**STAFF REPORT
CITY OF DONALD PLANNING COMMISSION**

FILE: Site Development Review #SDR 2023-01

REQUEST: **Site Development Review approval for demolition of the existing Donald Café structure and replacement with a new mixed-use building containing a restaurant on the ground floor and one residential apartment on the second floor. Other proposed site improvements include a covered eating patio, small plaza, landscaping, parking spaces in the rear to serve the apartment, and stormwater planters. A Lot Line Adjustment application was submitted concurrently to consolidate the three small underlying historic lots into one.**

LOCATION: The Donald Café. 10780 Main Street NE in Donald. Block 7 Lots 3, 4, and 5.

Utility Plan

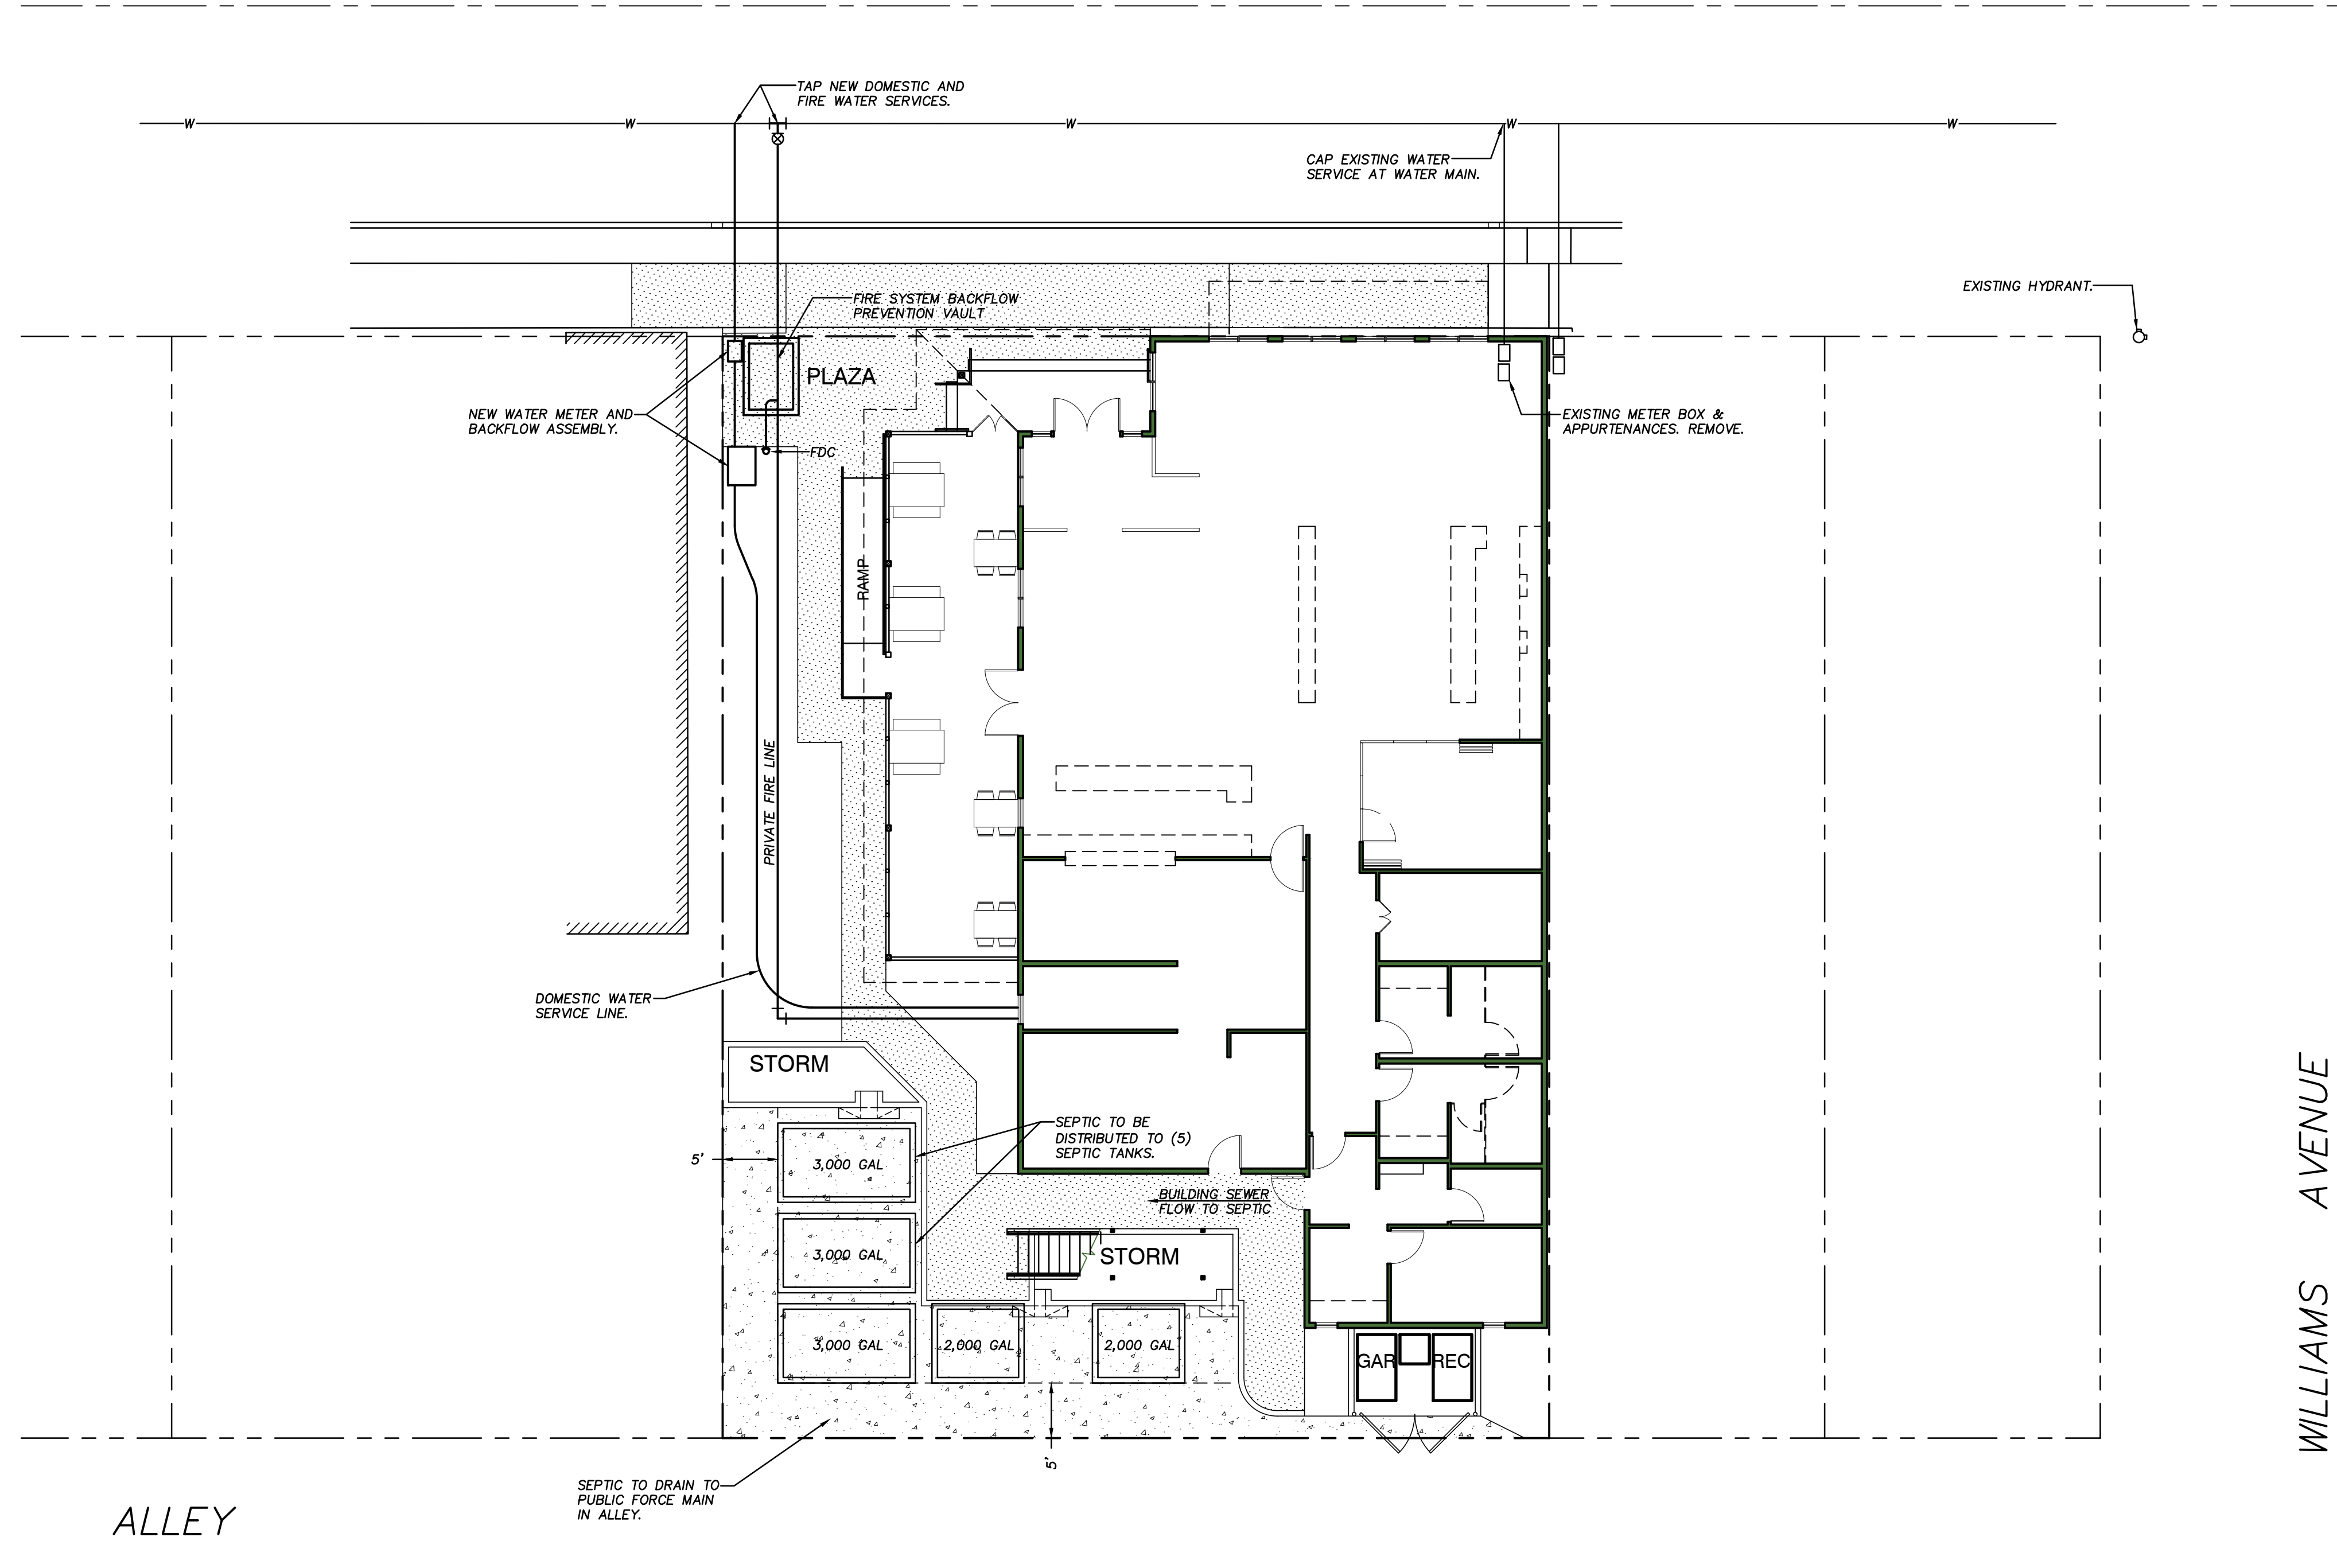
- Sheet C1.4, Utility Plan: Septic tanks system and new water meter/backflow service will require utility easements since they are located inside private property. A 15ft Public Utility easement is required for all utilities maintain by the City in private property.

- Frontage improvements and work on Main St ROW shall be reviewed and approved by Marion County.
- Sheet C1.4. Utility Plan, water meter service: The water meter and backflow device will be installed in accordance to Design Standards. The developer shall provide Water Fixture Unit count to properly sized the water meter and calculate SDC's and installation fee. I highly recommend a separate water meter to serve the apartment building for billing purposes.

- Sheet C1.4. Utility Plan: Number of septic tanks being proposed seem excessive, City Engineer and PW will have to review DEQ's table of recommendation and finalize number of tanks needed to serve the project. The way that is being proposed now will highly impact the sewer SDC's and installation fees.

C1.4 – Provide sprinkler system flow and pressure so the City can determine if the water system has adequate pressure. If not then a fire pump may be required.

C1.4 – Drawing notes existing meter is to be removed. I suggest replacing it with a meter to serve the apartment separate from the restaurant.
